CONTRACT CHANGE ORDER NO. 203 S2
SHEET 2 OF 8

MARK	DATE	DESCRIPTIONS	BY	CH'D	CCO
3	11/04/11	TOWER ELEVATOR EXTENSION	JNB	FS	203S2
2	08/26/11	ELEVATOR DETAILS	JNB	FS	85
1	07/17/09	ELEVATOR DETAILS	JNB	FS	85

ELEVATOR DETAIL NO. 1

SAN FRANCISCO OAKLAND BAY BRIDGE
EAST SPAN SEISMIC SAFETY PROJECT
SELF-ANCHORED SUSPENSION BRIDGE (SUPERSTRUCTURE & TOWER)

ELEVATOR DETAIL NO. 2

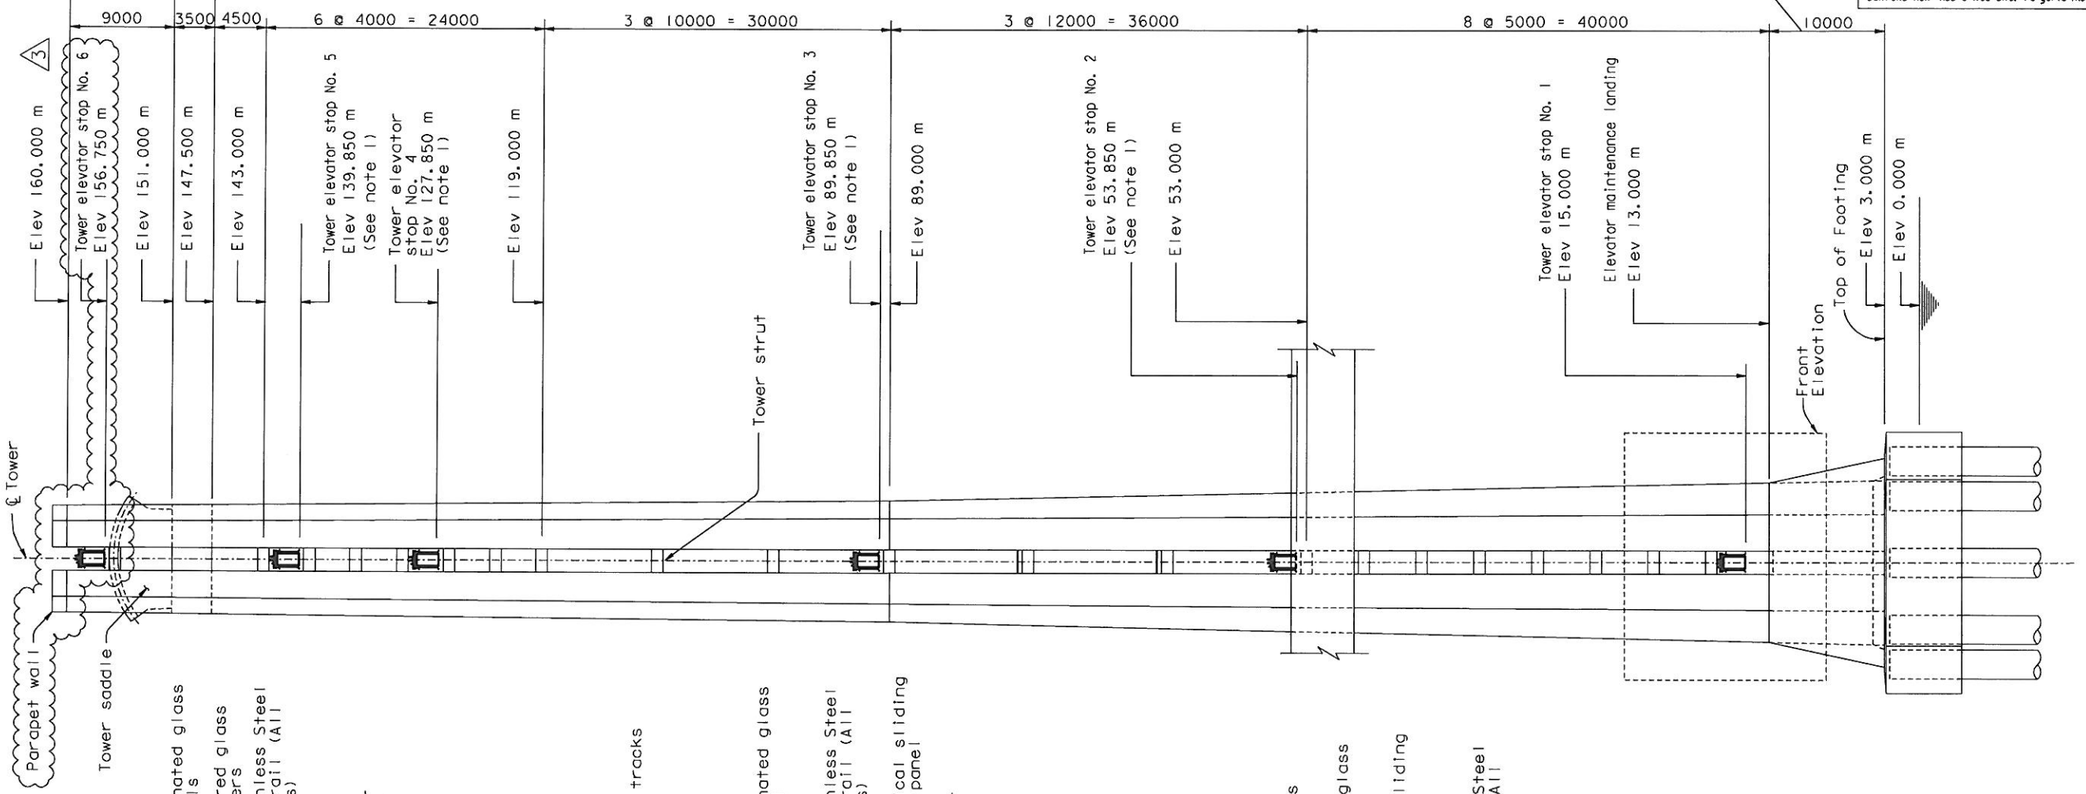
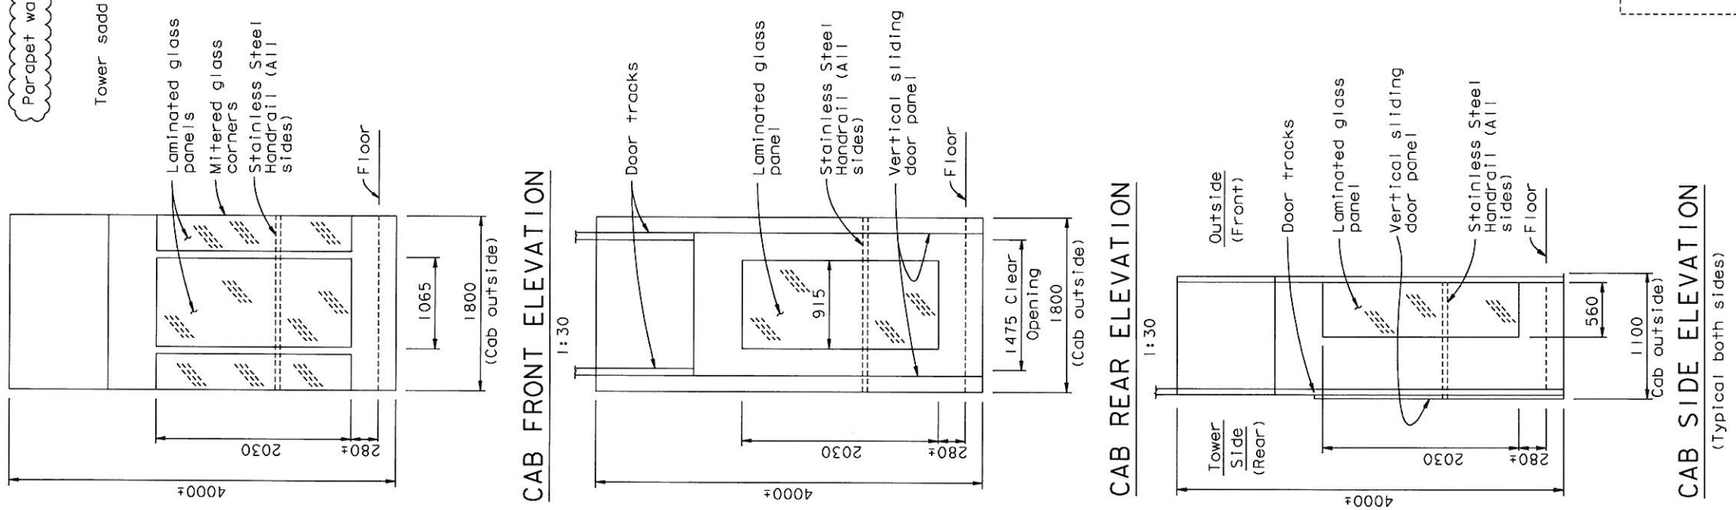
MARK	DATE	DESCRIPTIONS	BY	CH'D	CCO
3	11/04/11	TOWER ELEVATOR EXTENSION	JNB	FS	203S2
2	08/19/11	ELEVATOR DETAILS	JNB	FS	85
1	07/17/09	ELEVATOR DETAILS	JNB	FS	85

TOWER ELEVATOR SUPPORT DETAILS NO. 1

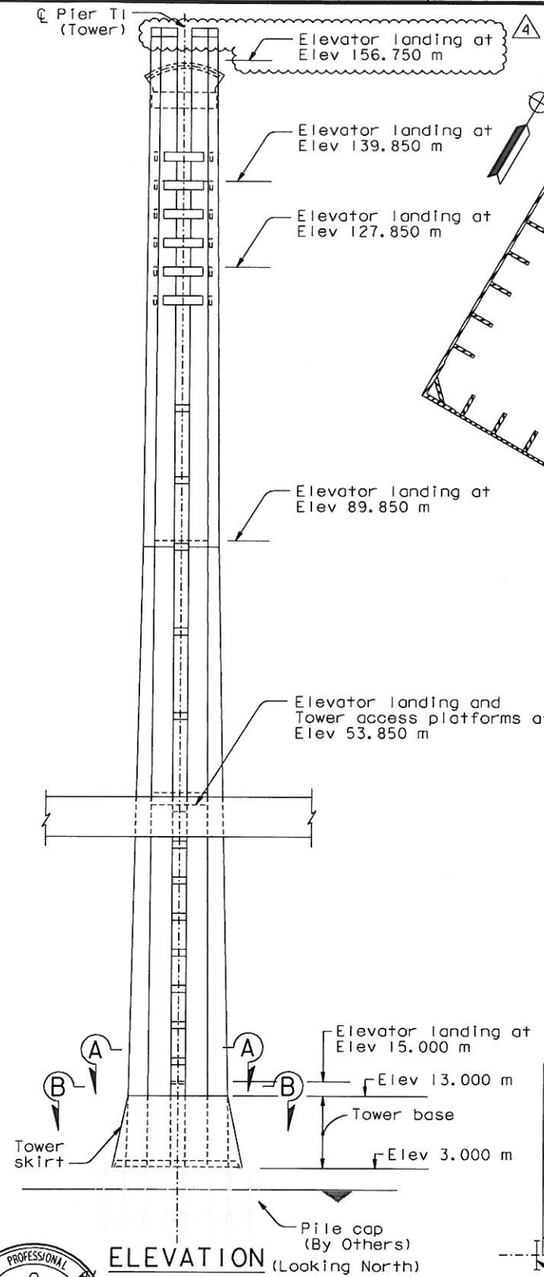
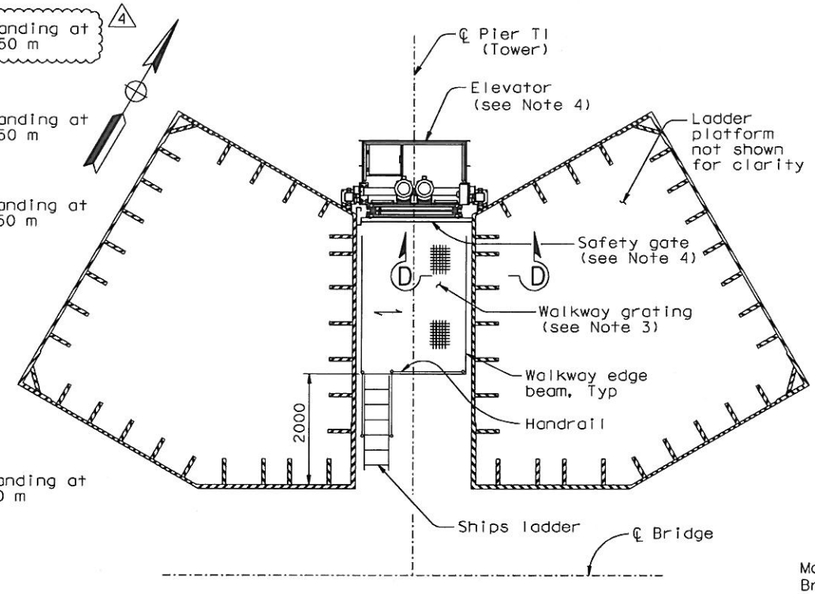
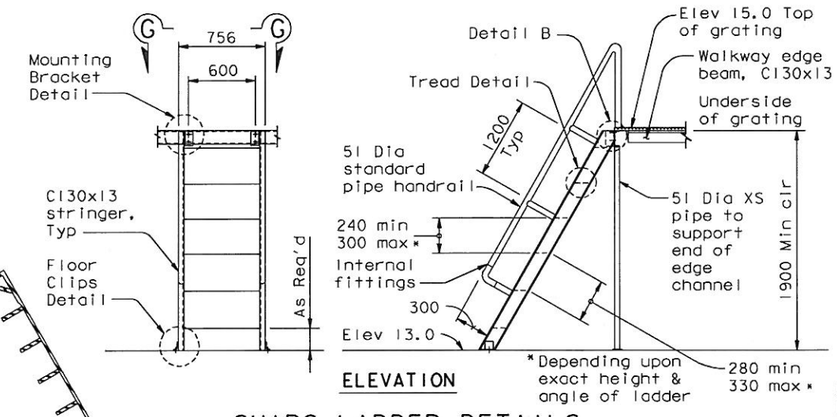
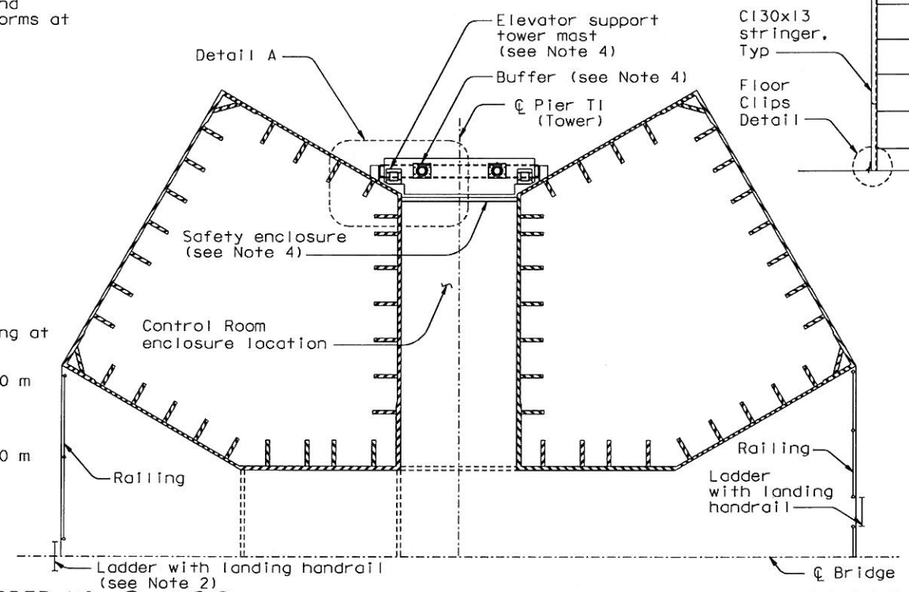
MARK	DATE	DESCRIPTIONS	BY	CH'D	CCO#
4	11/04/11	TOWER ELEVATOR EXTENSION	TH	MN	20352
3	08/19/11	ELEVATOR DETAILS	TH	MN	85
2	10/15/10	HANDRAIL AND PLATFORMS	TH	MN	114
1	07/17/09	ELEVATOR DETAILS	TH	MN	85

TOWER ELEVATOR ENCLOSURE DETAILS NO. 1

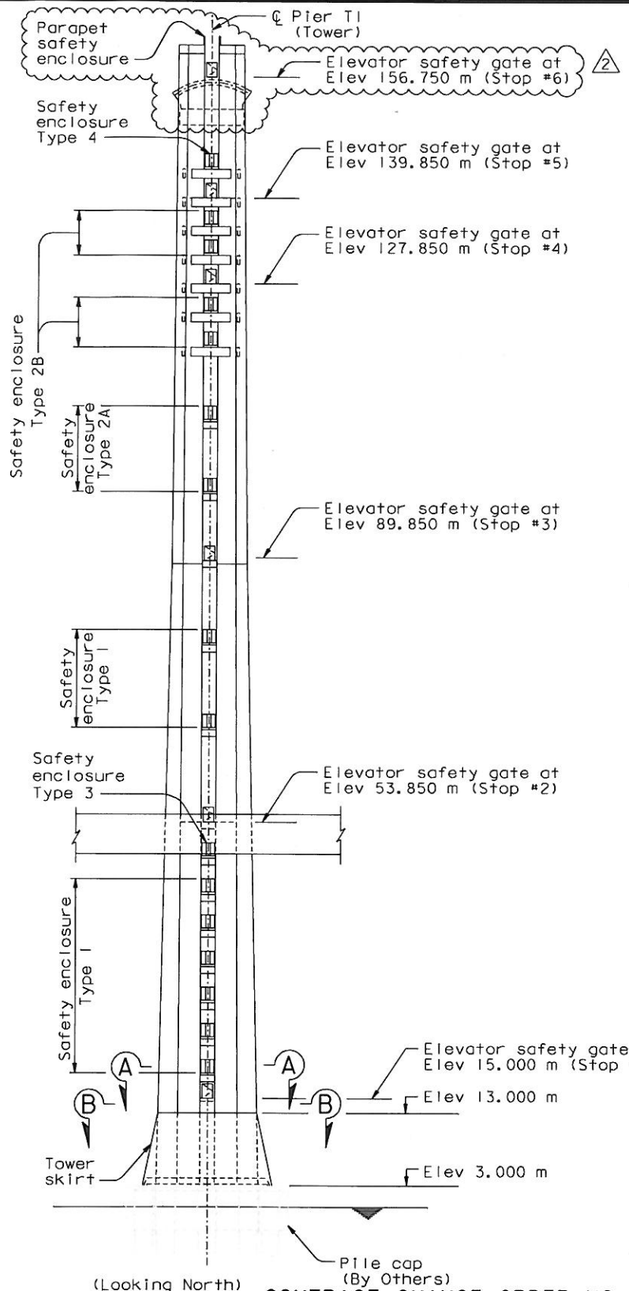
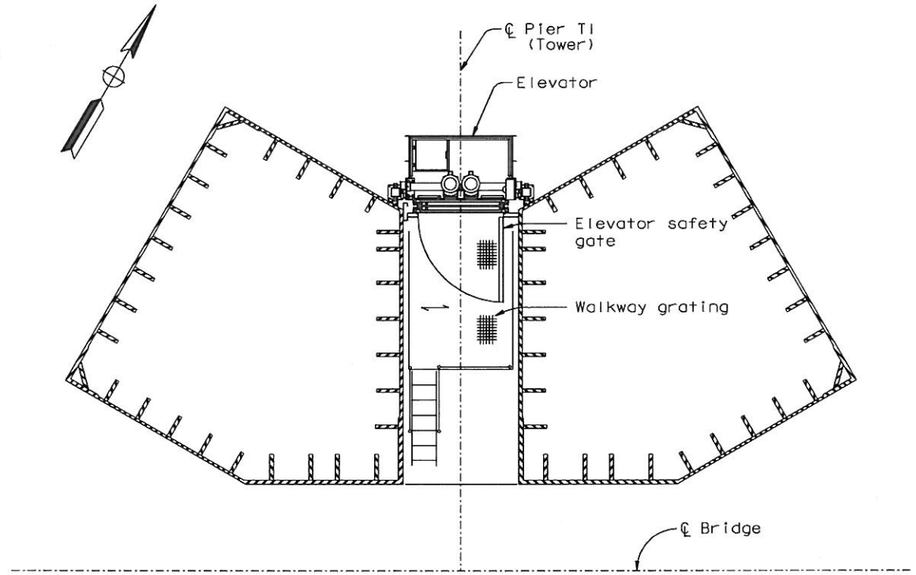
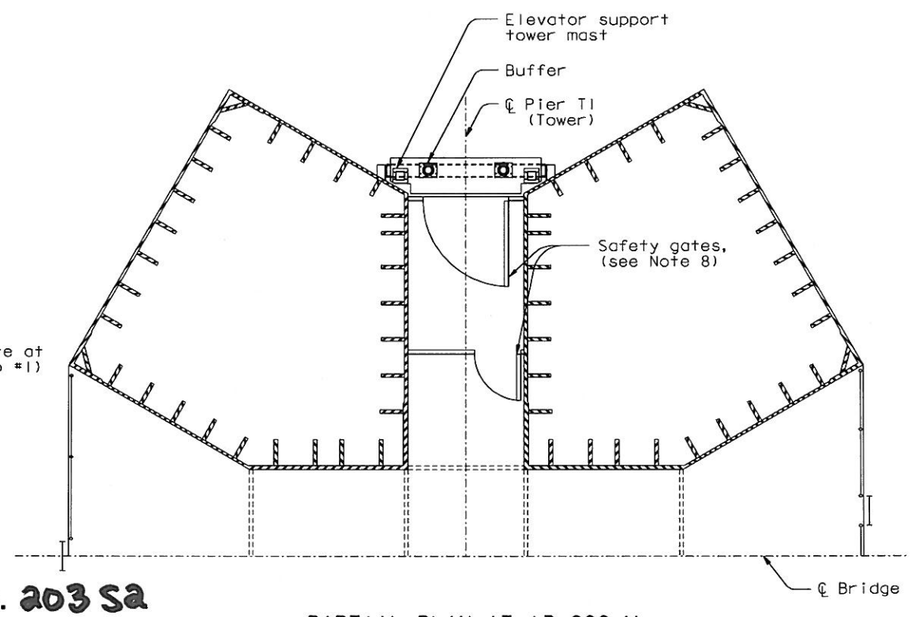
MARK	DATE	DESCRIPTIONS	BY	CH'D	CCO#
3	06/13/12	TOWER ELEVATOR EXTENSION	AB	TH	203S2
2	11/04/11	TOWER ELEVATOR EXTENSION	AB	TH	203S2
1	11/02/11	ELEVATOR DETAILS	GM	TH	85
0	08/26/11	ELEVATOR DETAILS	GM	TH	85

TOWER ELEVATOR ENCLOSURE DETAILS NO.6

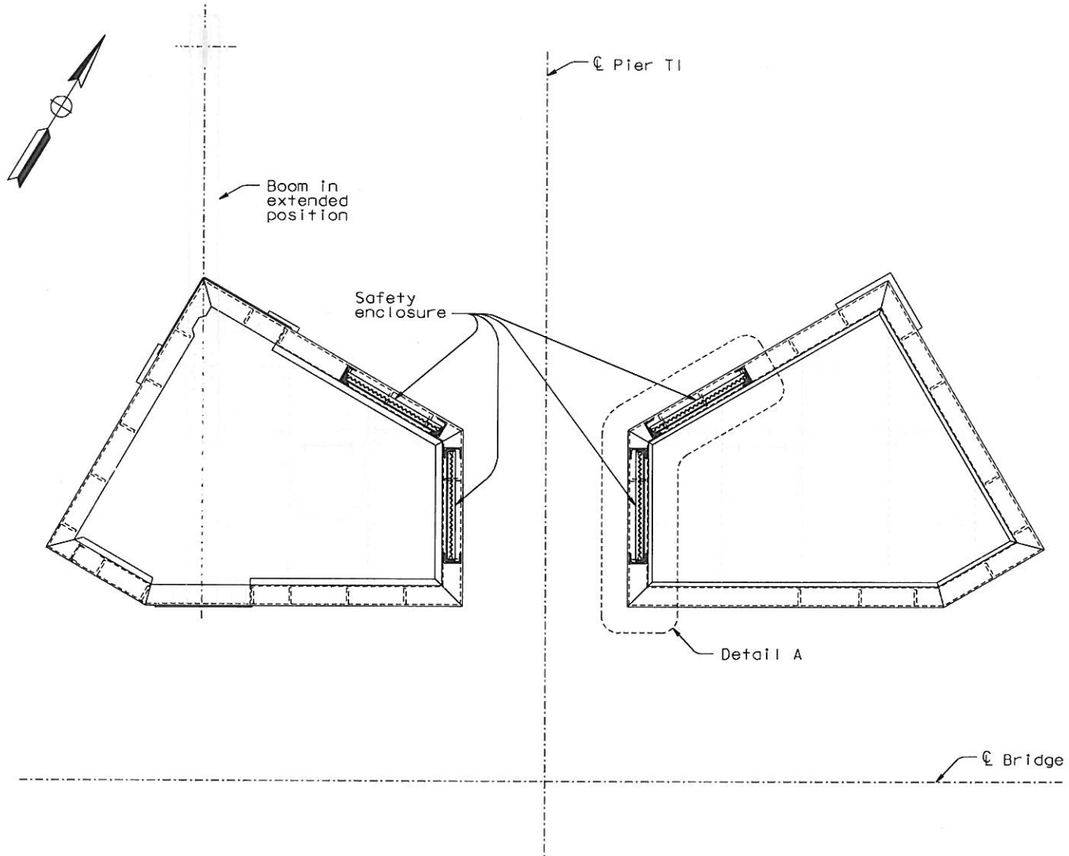
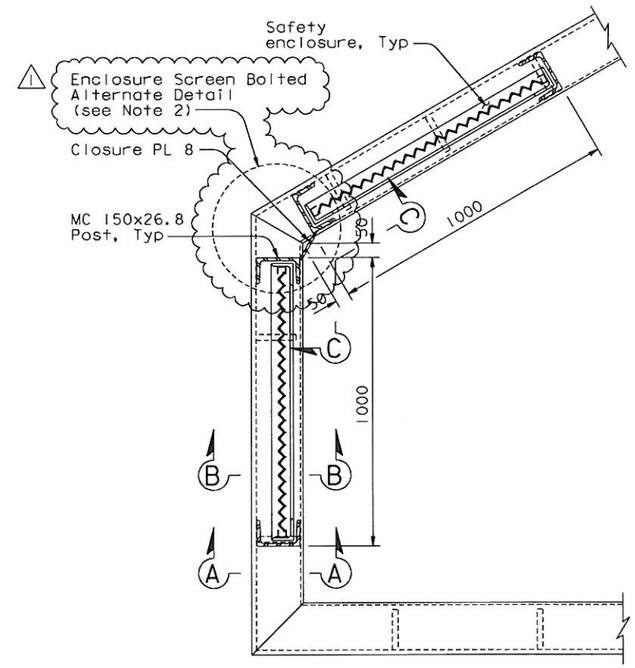
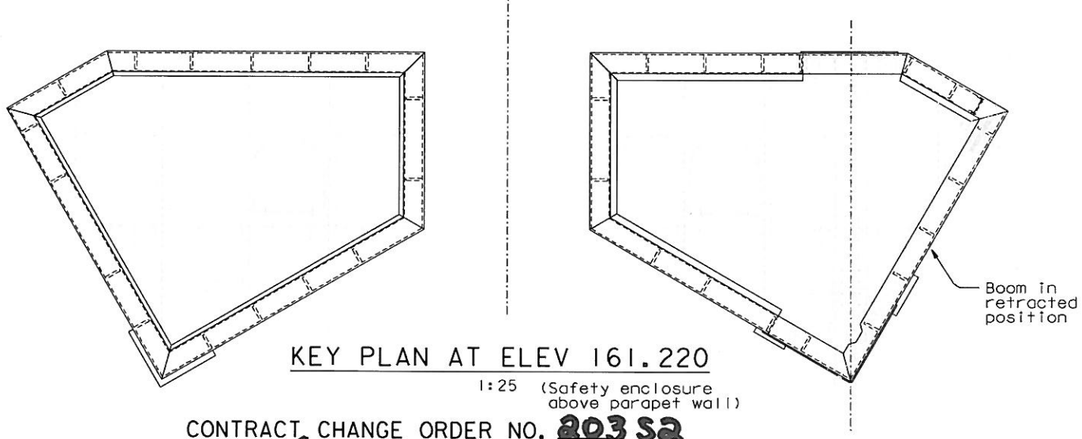
MARK	DATE	DESCRIPTIONS	BY	CH'D	CCO#
1	05/16/12	TOWER ELEVATOR SAFETY ENCLOSURE	NV	MN	203S2
0	11/04/11	TOWER ELEVATOR SAFETY ENCLOSURE	NV	MN	203S2

TOWER ELEVATOR ENCLOSURE DETAILS NO. 7

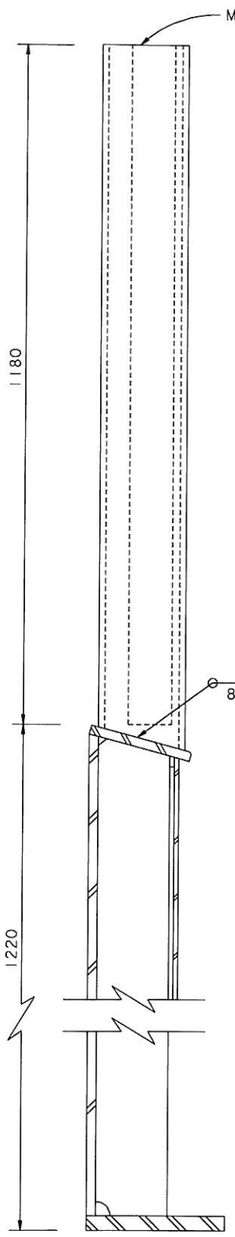
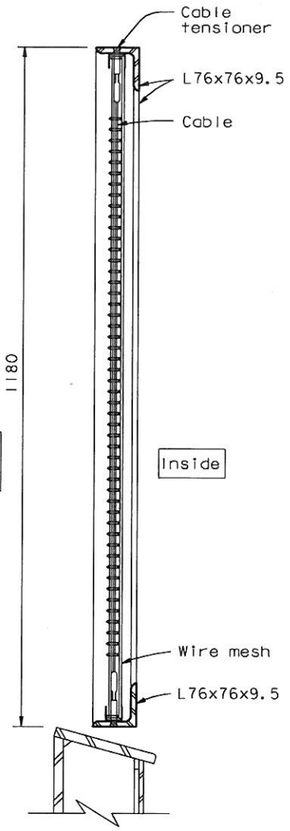
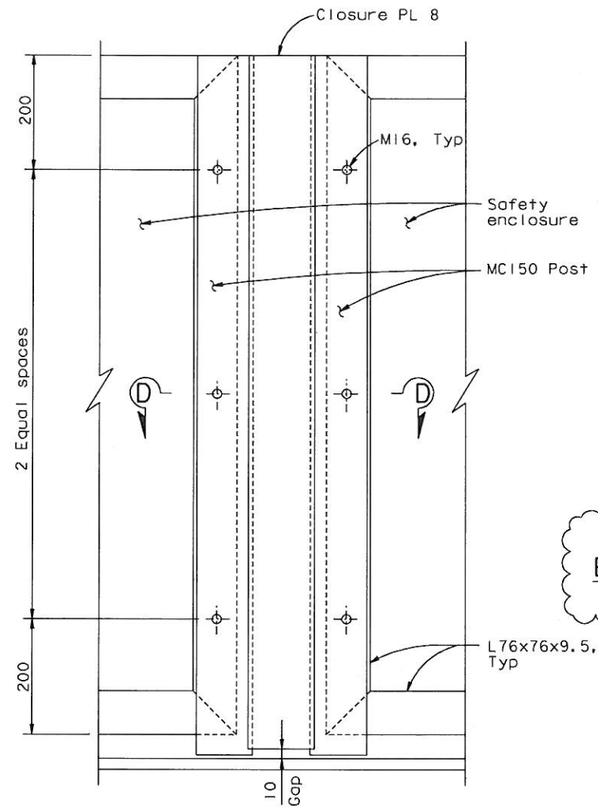
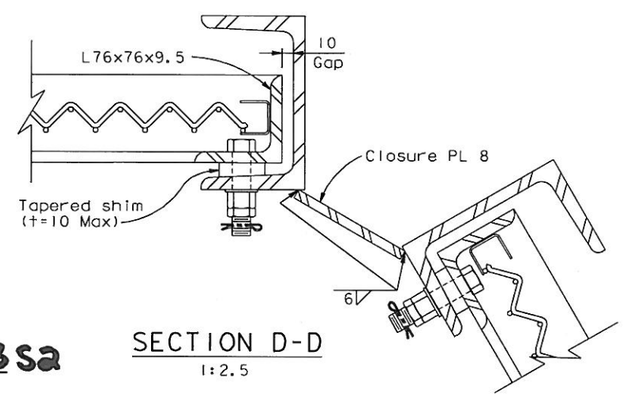
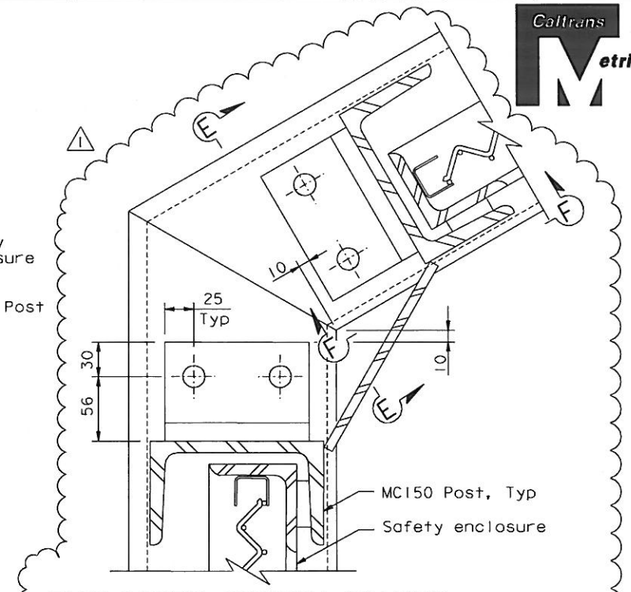
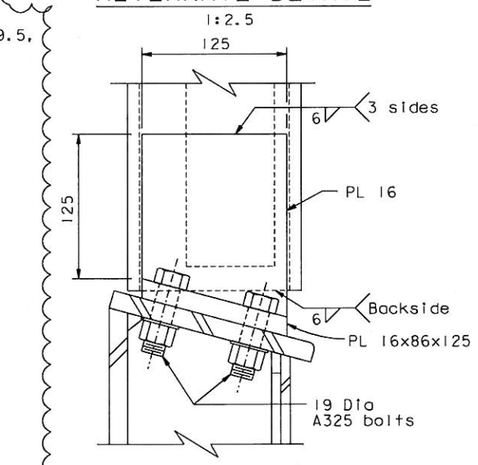
MARK	DATE	DESCRIPTIONS	BY	CH'D	CCO#
1	05/16/12	TOWER ELEVATOR EXTENSION	NV	MN	203S2
0	11/04/11	TOWER ELEVATOR EXTENSION	NV	MN	203S2

1. For enclosure details not shown, see "Tower Elevator Enclosure Details No.2" sheet.
2. At the Contractor's option, Enclosure Screen Bolted Allternate Detail may be used in lieu of fillet weld.
